BRUNSWICK STEAM ELECTRIC PLANT, UNIT NOS. 1 AND 2  
DOCKET NOS. 50-325 & 50-324/LICENSE NOS. DPR-71 & DPR-62  
REQUEST FOR LICENSE AMENDMENT  
STEAM LEAK DETECTION INSTRUMENTATION NUMAC UPGRADE

BRUNSWICK STEAM ELECTRIC PLANT, UNITS 1 AND 2  
NRC DOCKET NOS. 50-325 & 50-324  
OPERATING LICENSE NOS. DPR-71 & DPR-62  
REQUEST FOR LICENSE AMENDMENT  
STEAM LEAK DETECTION INSTRUMENTATION NUMAC UPGRADE

### BASIS FOR CHANGE REQUEST

FIGURE 1

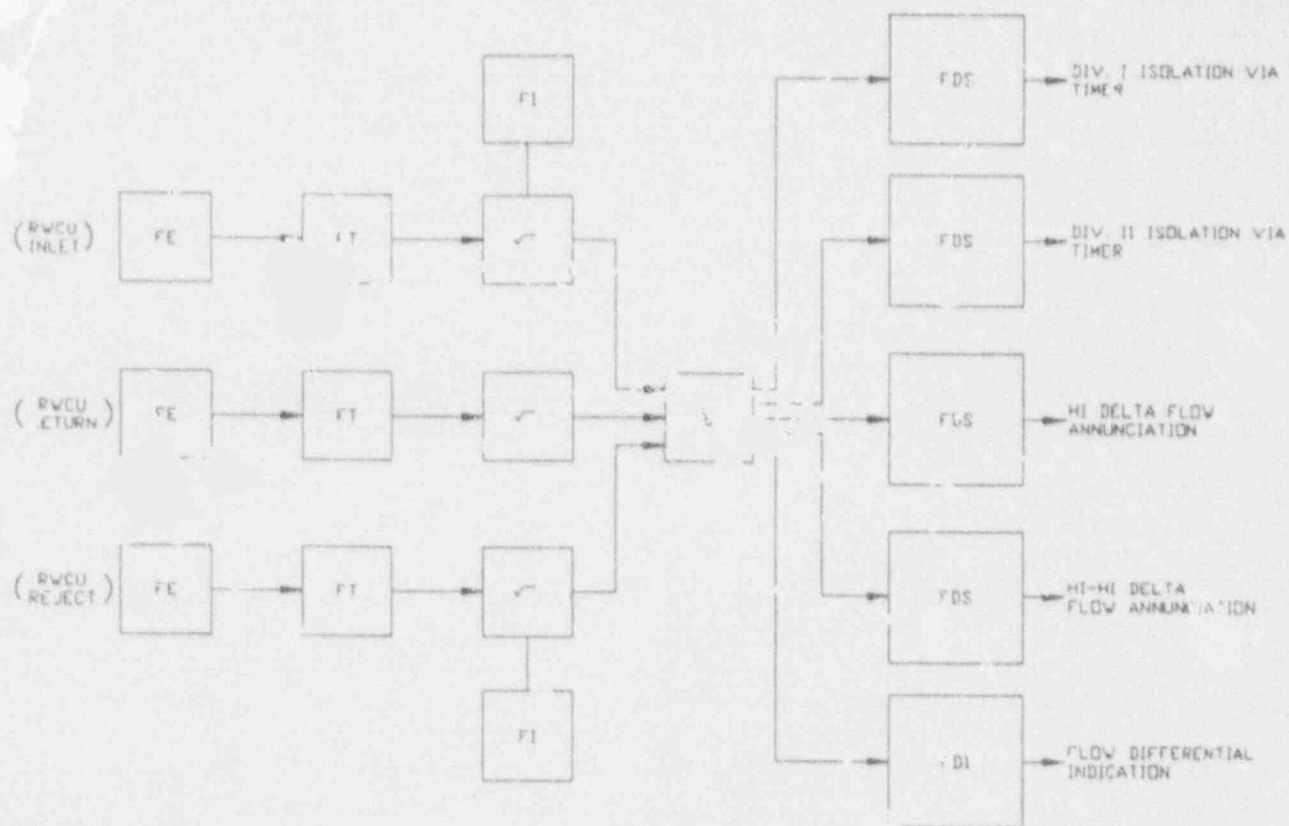
The reactor water cleanup high differential flow alarm/trip is based on the difference between the input flow from the reactor coolant system and the sum of the two output flows (one is return to the feedwater system; the other is reject flow to the main condenser or the radwaste system). The difference between the input and output flows is assumed to be leakage. The proposed NUMAC system will incorporate the enhanced feature of process flow density compensation based on process temperature. This will provide the operator more accurate reactor water cleanup system leak rate information. See Figures 1 and 2 for a basic diagram of the RWCU Differential Flow Instrument/Control System.
